RESPONSE TO NRC QUESTIONS
ON PALO VERDE
SEISMIC HAZARD ANALYSIS

Arizona Public Service Company
Phoenix, Arizona

Risk Engineering, Inc.
Golden, Colorado

April 7, 1993

Figure 3-7: Hazard results using EPRI/SOG shear-wave velocity profile; PGA

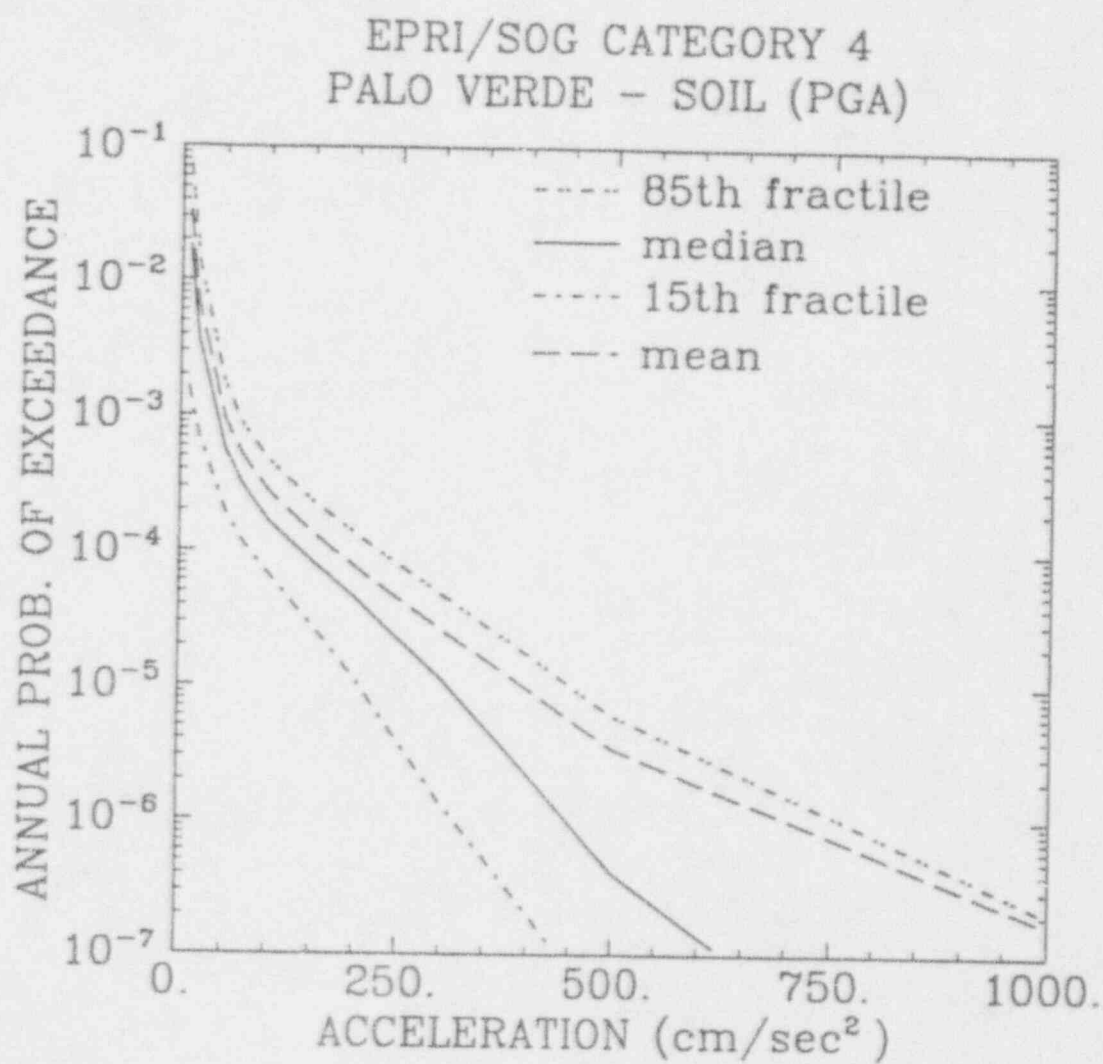
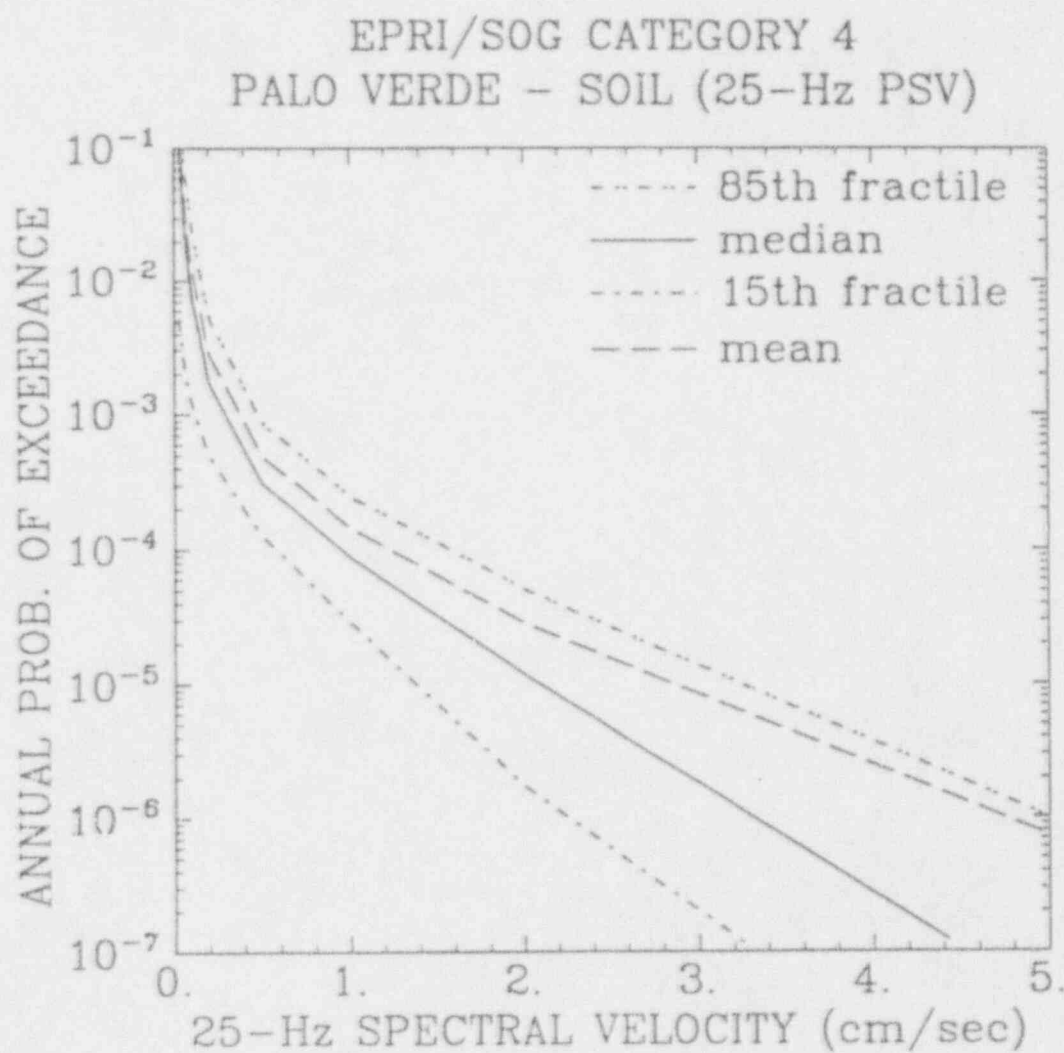
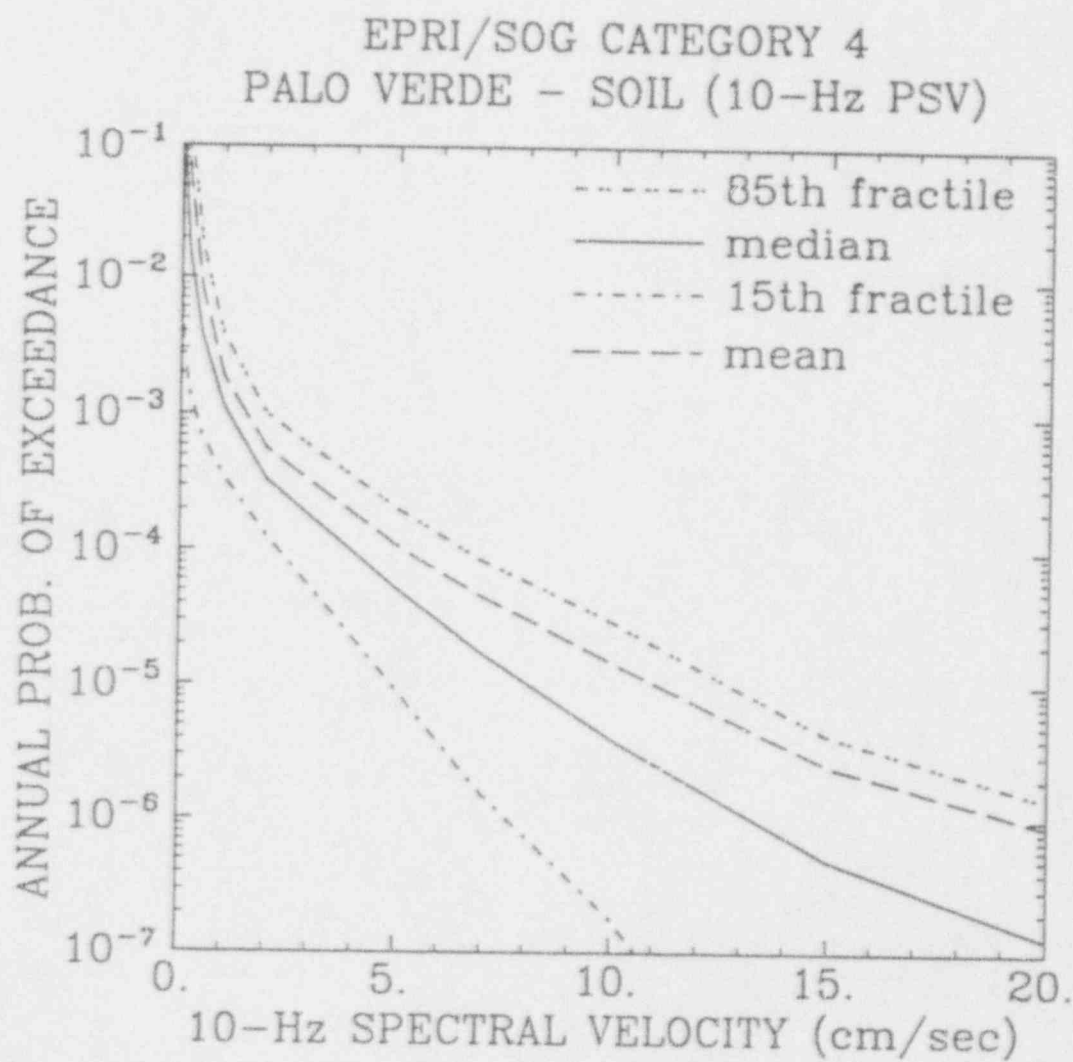
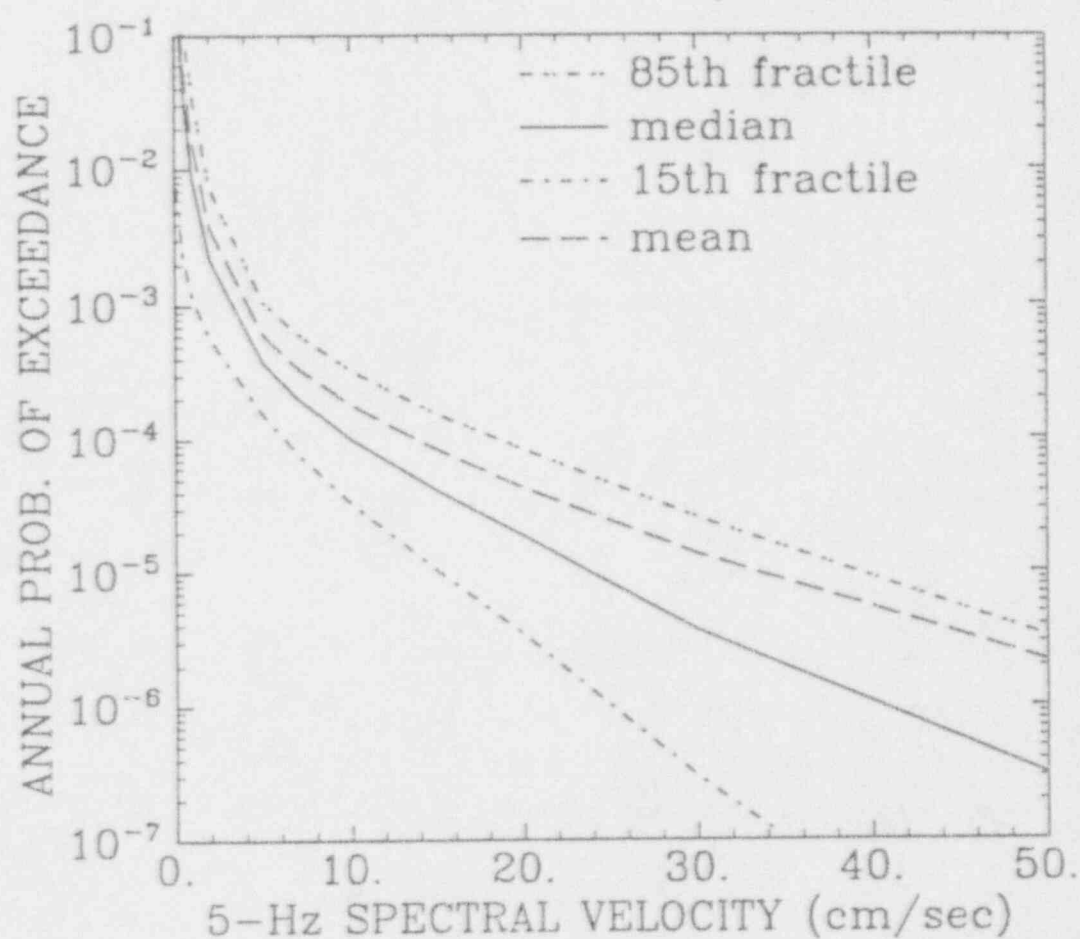
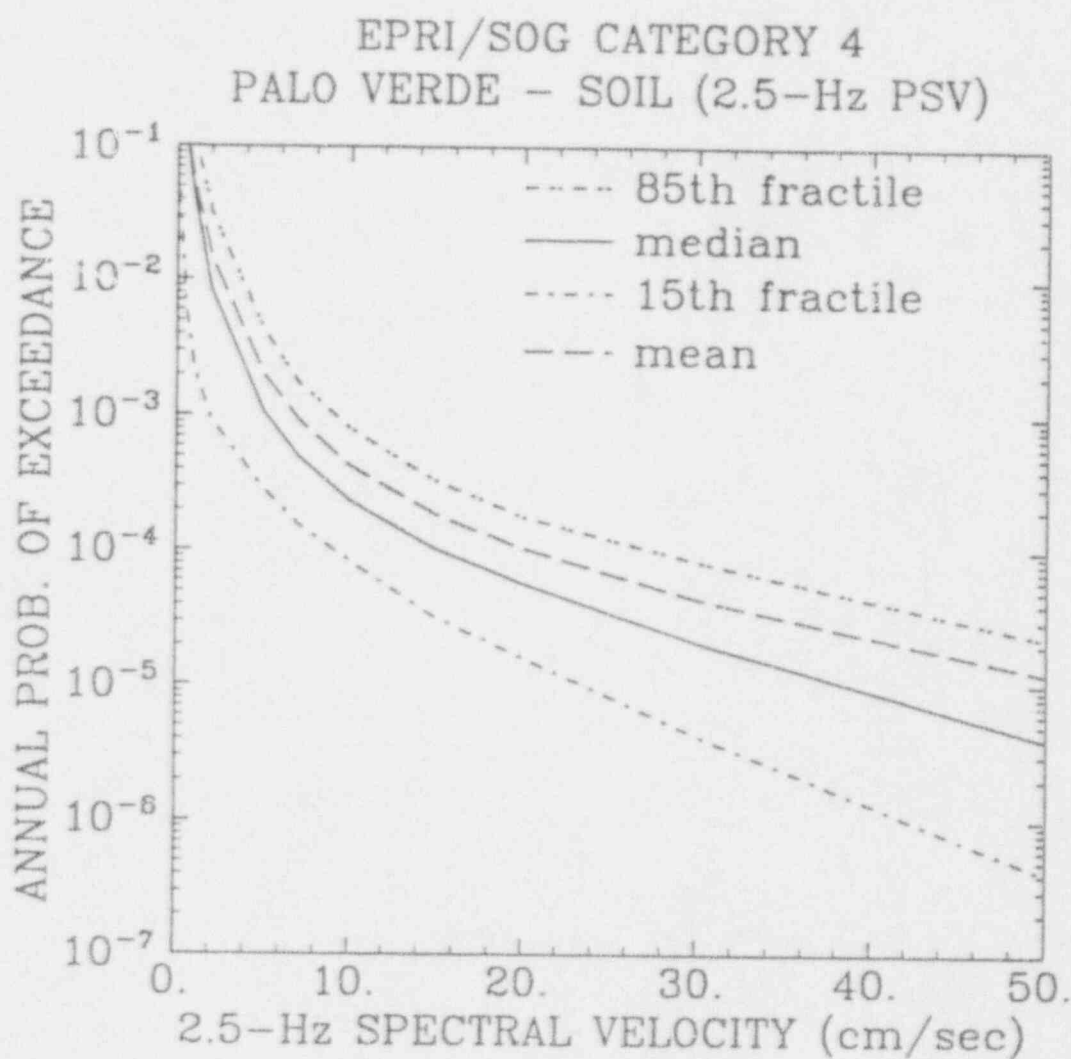
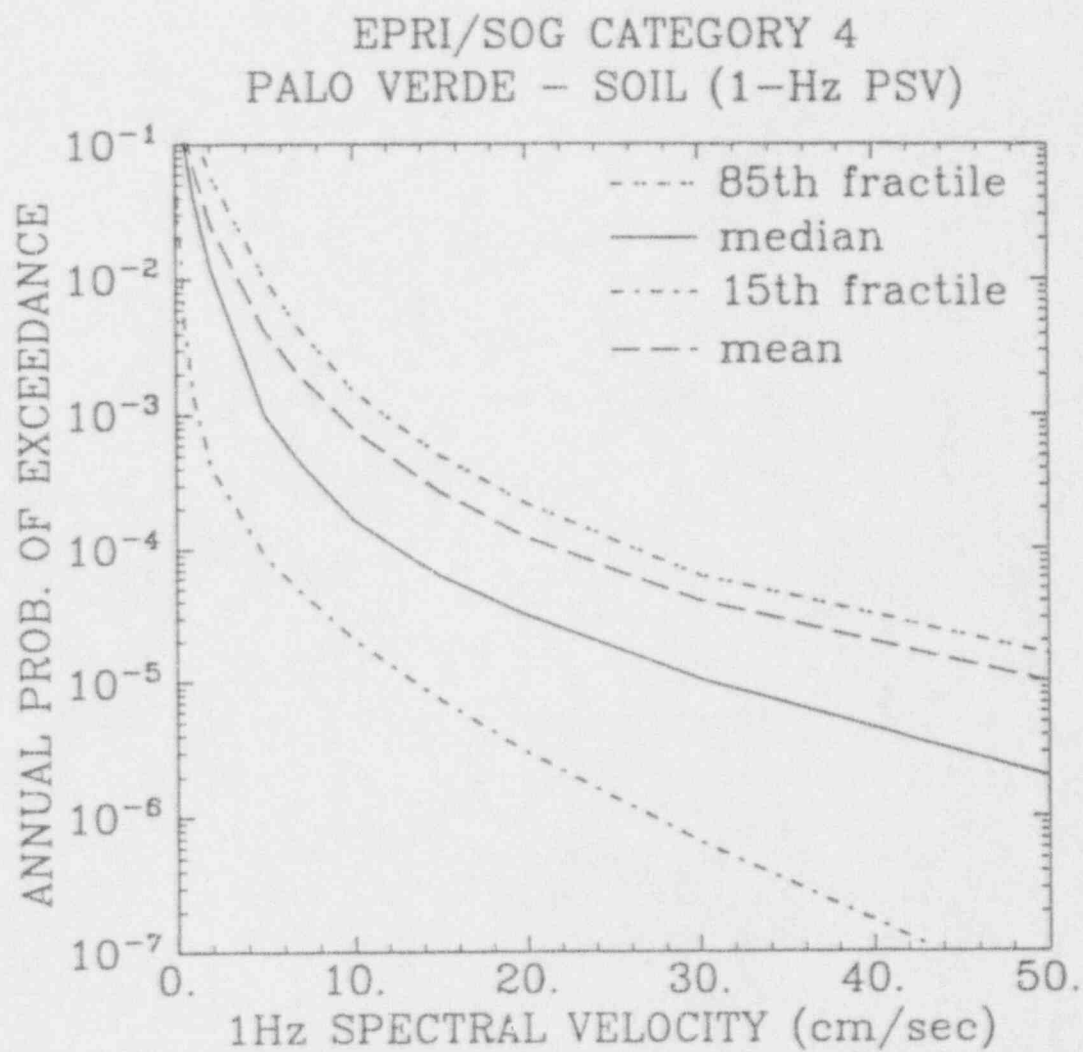
Question II-3 (Soil Characteristics): "The supplemental study (Ref. 3) uses the modulus reduction and damping curves developed by Seed and Idriss and a "Standard Soil Profile." The staff recommends that a sensitivity study be performed using the range of shear degradation models shown in Figure 2 and that it assesses the influence of using the upper range and lower range of the soil profiles shown in the supplemental report (Ref. 3, Supplemental Report, Figure 2-2)."

The curves labeled EPRI/SOG Category IV in Figures 3-1 through 3-6 indicate the amplifications from the EPRI/SOG Category IV amplification factors (i.e., using the 1988 EPRI/SOG profiles, modulus, curve, and damping curve shown in Figures 2-2 and 2-3 of Reference D). The EPRI/SOG amplification factors are generally below the base case except for 2.5 and 5 Hz, where they indicate higher amplification (this is the profile referred to in Question II-3). To determine the effect on hazard, these amplification factors were used to compute hazards at Palo Verde, and the results are shown in Figures 3-7 through 3-12 for PGA and the five frequencies. Quantitative probabilities are presented in Table 3-1, and percent changes in hazard (probability) are presented in Table 3-2.

Some of these sensitivity studies indicate increases in hazard, but these results should not be viewed as realistic. The EPRI-SOG shear wave profile was developed as a generic model for deep soil sites in the eastern United States. The results from this model (Tables 3-1 and 3-2) are not appropriate to use at Palo Verde where site-specific velocities are available. In particular, the upper-bound EPRI/SOG velocity results (Tables 3-5 and 3-6) are not appropriate to use, to characterize the hazard at Palo Verde. The sensitivity study that assumed a 30% coefficient of variation is also not appropriate (Tables 3-7 and 3-8). Shear wave velocities do not vary in a perfectly-correlated way with depth, and the EPRI model of velocity correlation (which was used for the base case results, Reference C) is a more accurate and realistic model to determine soil response. Furthermore, it will be shown in pages 47 and 48 of this report that the conclusion of a 0.3g RLE would not be affected by the use of any of the site amplification factors considered in this sensitivity study.
